CHNA Questions
Regarding Proposed Ruskin Street Parking Garage Development
Provided to The Ottawa Hospital on August 24, 2013

REFERENCE: CastleGlenn Traffic & Transportation Overview

REFERENCE: Lloyd Phillips Planning Rationale Application for Zoning By-Law Amendment Proposed Ruskin Street Parking Facility 45 Ruskin Street.

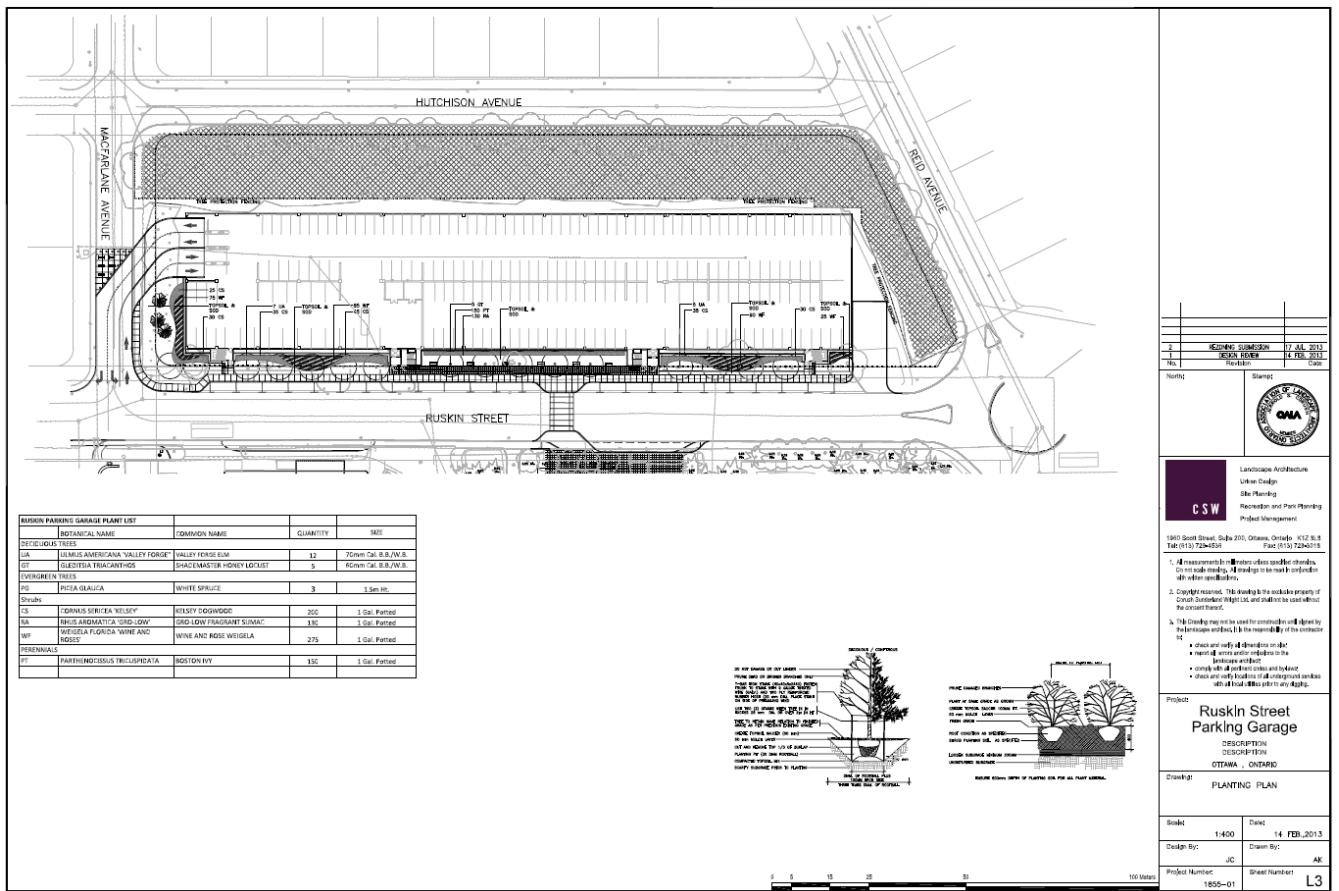
- c. Please confirm table 1.1 provides exceptions being requested to the i2 Zoning for this property.

Table 1.1 outlines the site specific exceptions to the proposed I2 Zone.
